RE: Completeness Review for Class 3 Site Plan Review for Property Located at 4555 Liberty Road S

SUBWAY
SUNNYSLOPE CENTER
4555 LIBERTY RD. SOUTH
SALEM OREGON

A1.0

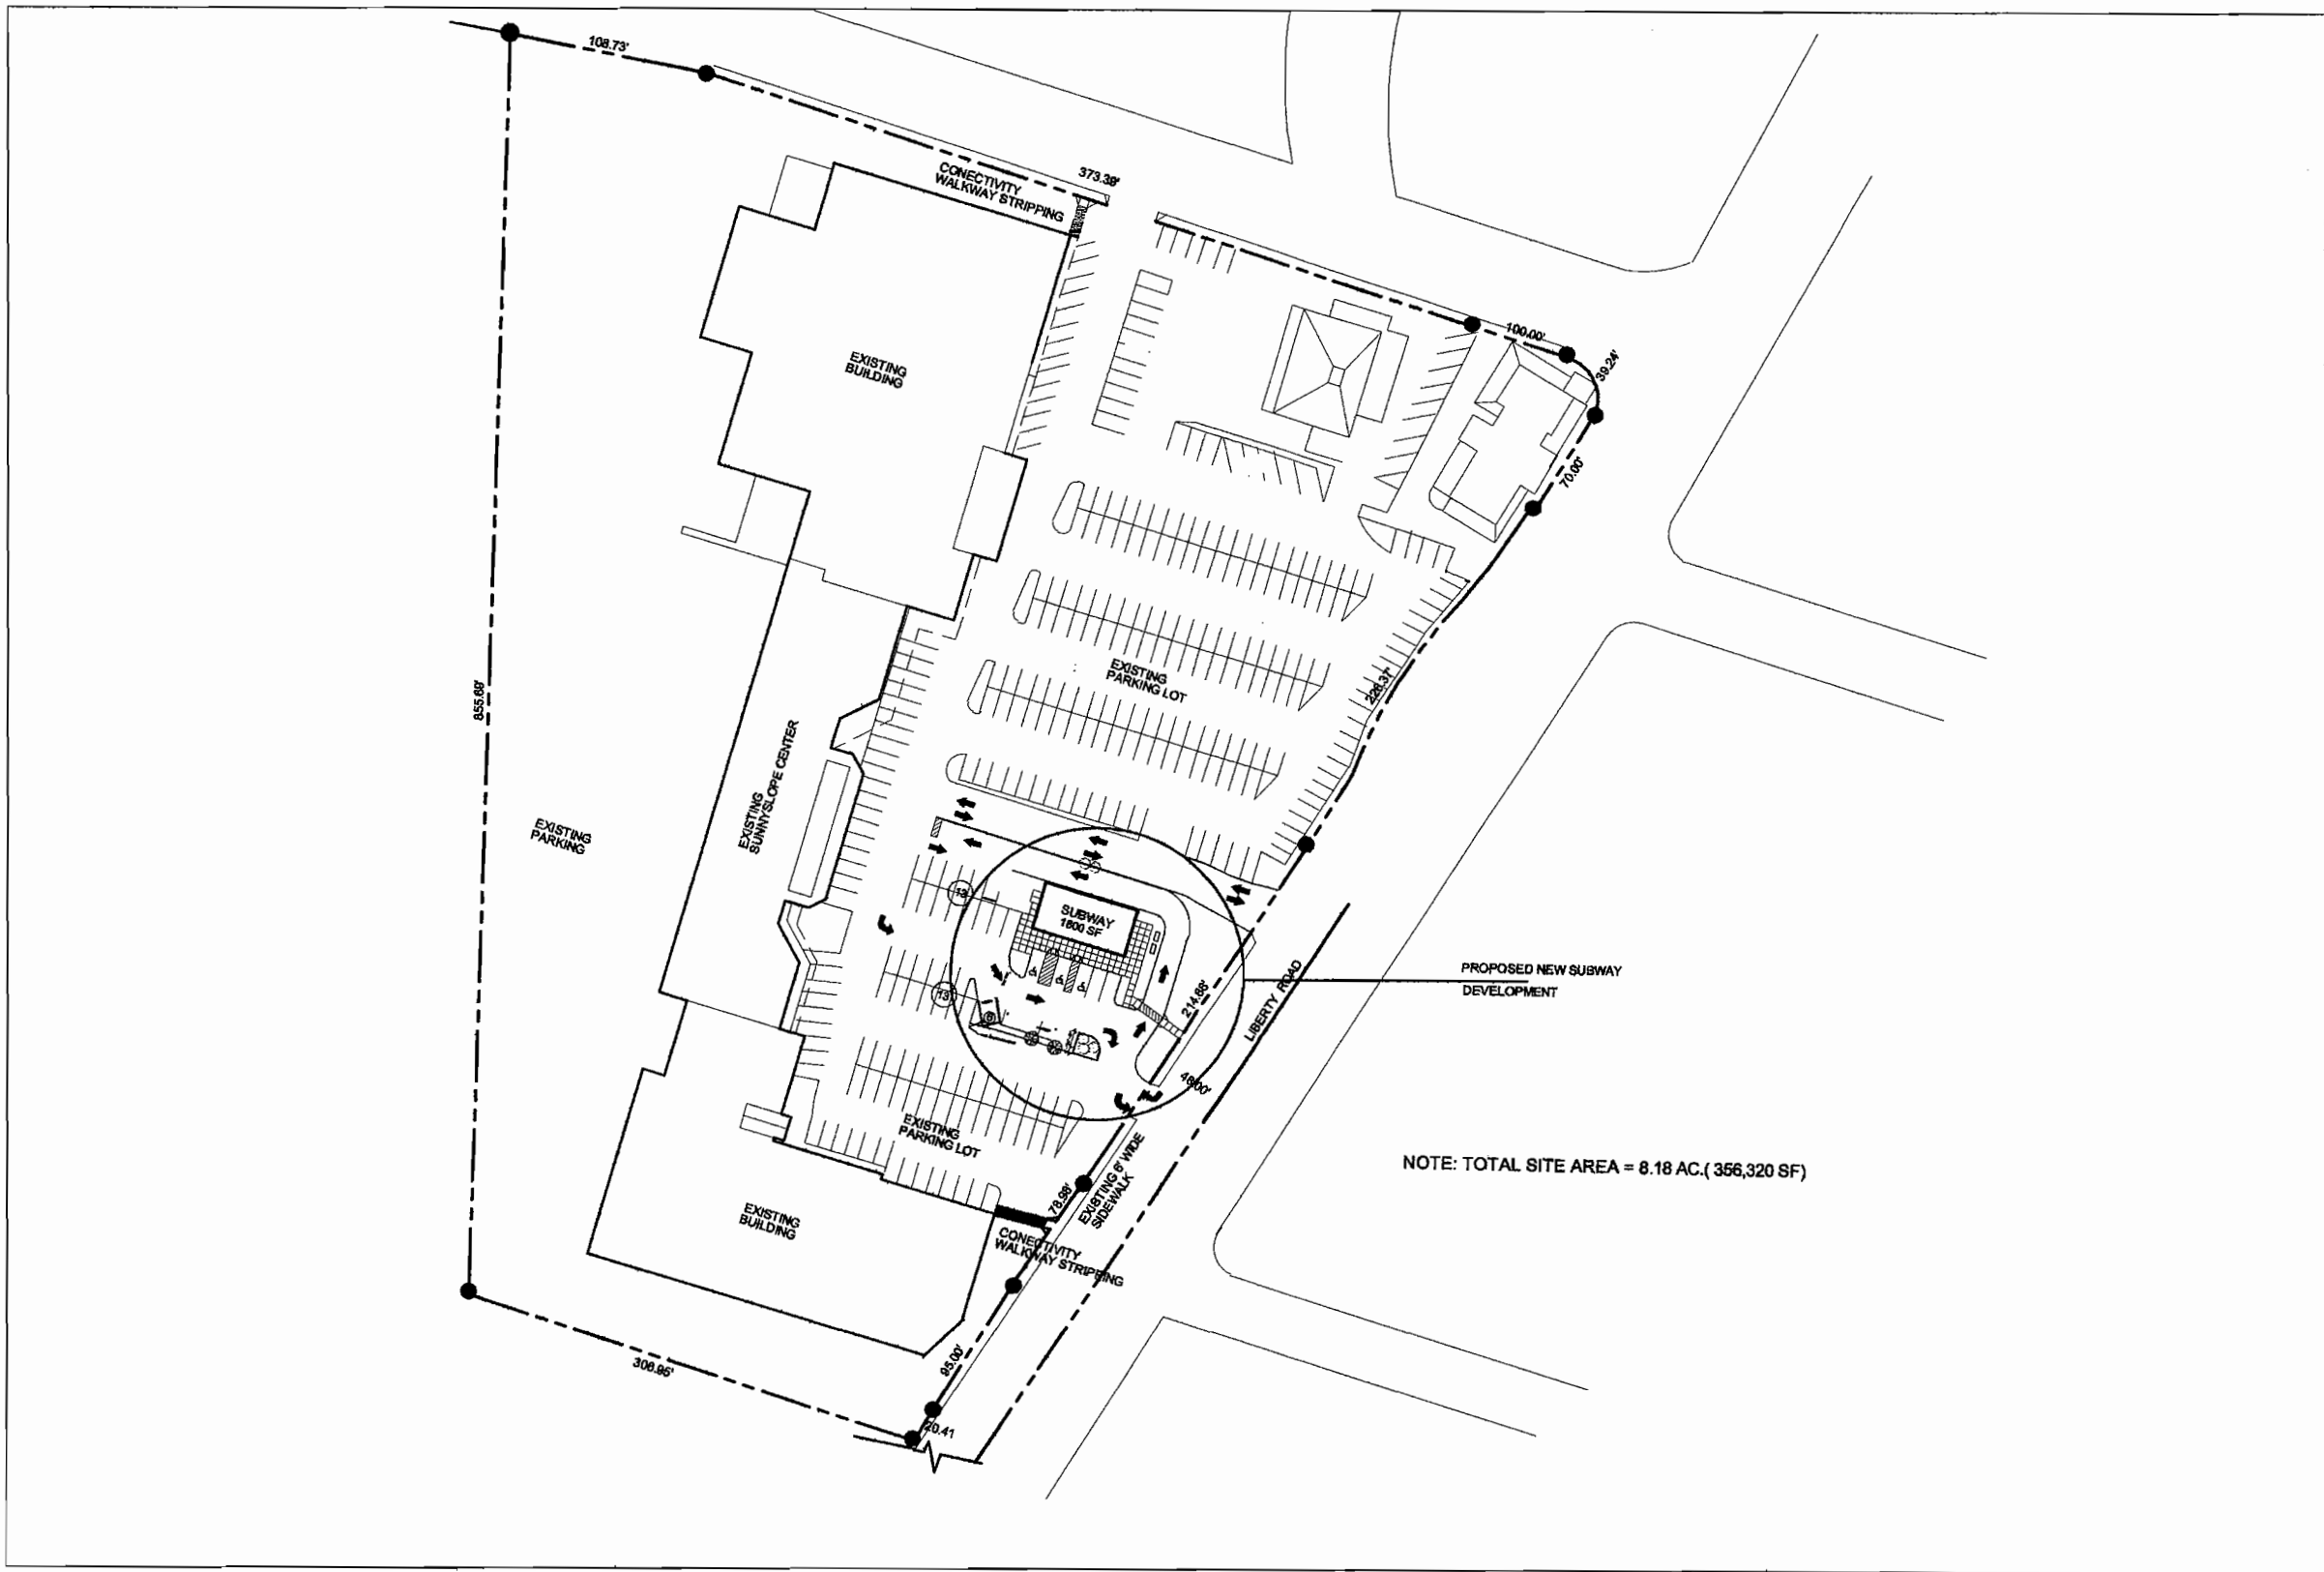
- **Existing Conditions:** The proposed site plan and existing conditions plan do not match the approved site plans the City has on file in the following way(s):

Off-street parking area, trash enclosure, bicycle rack, and landscaping to the south and west of the Subway building. Based on permit history and aerial imagery, it appears a trash enclosure, bicycle rack, and some landscaped areas were removed, and the off-street parking area was reconfigured, sometime around 2011-2012. The proposal will need to include returning this area to the approved layout (see **Attachment A**), or this portion of the development site will need to be reviewed under the current standards of the SRC along with the area containing the proposed Sherwin Williams building. The applicant can also submit evidence this work was done with the necessary approval from the City, though I was unable to locate anything in our system which would indicate this.

This work was performed under a previous owner and it is clear that some of the concrete work and planting areas did not match the approved plan at the time of planning inspection between 2011-2012. Under the proposed scope of work for the adjacent Sherwin Williams building, we will expand the landscape area to the east of the Subway building per initial Sherwin submission and will add a pedestrian connection to the east from the Subway entry and provide the required bike rack.
